Published date	12/12/2018
Document number	SUPAIR_2018/12/002
Page number	1 / 2

SUBJECT : ACRO BASE harness

Lateral adjustment straps tear

Facts/ Ascertainment :

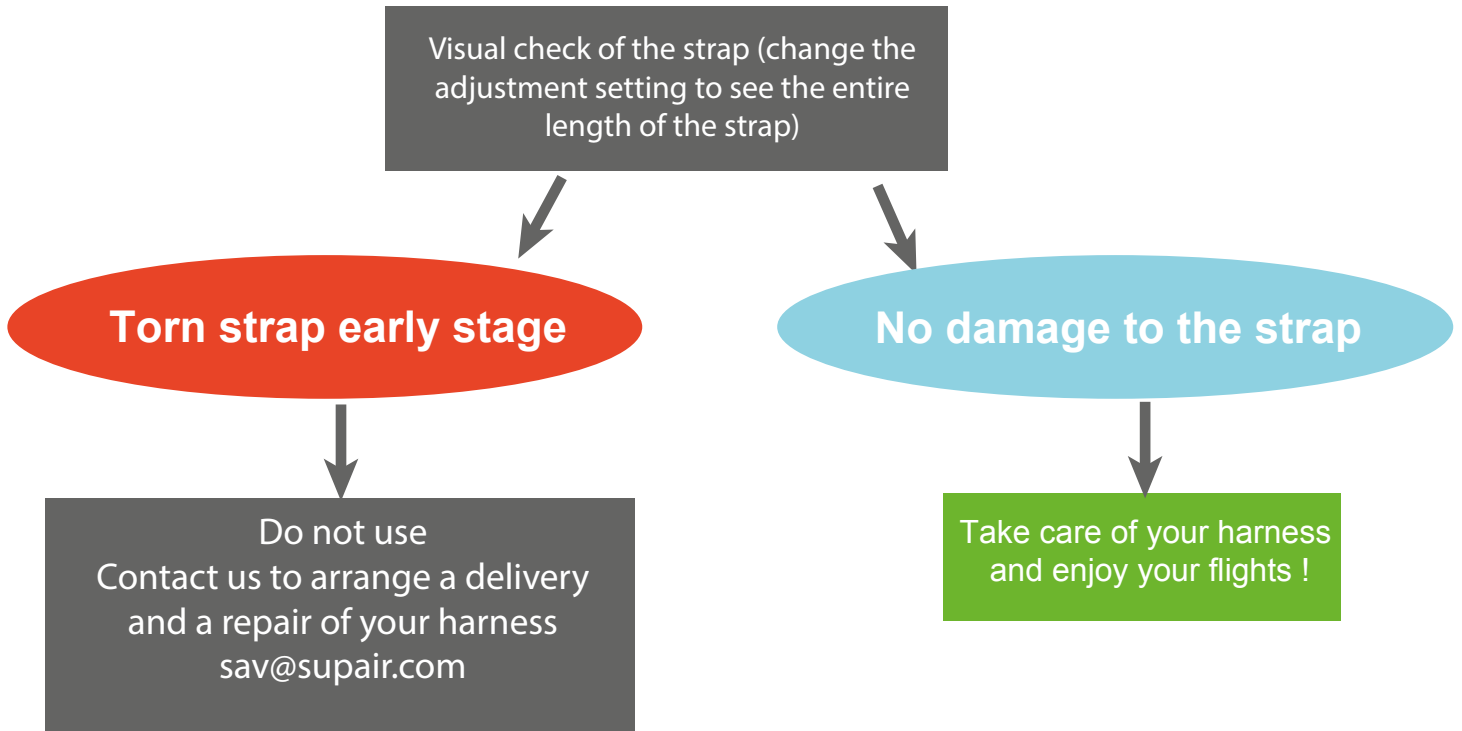
Caution, the side backrest adjustment strap (higher one) may be damaged in the adjustment buckle.

The upper lateral backrest tilt adjustment strap might start to tear during use. This tear can lead to a complete rupture of the strap. This specific strap does not affect the harness' structure but might impact the support of the pilot, making the harness uncomfortable especially if the second adjustment strap is not set properly.

This can also lead to a lack of position awareness and support of the pilot and might have consequences on certain phases of flight.

DELAIS : The inspection must be done immediately
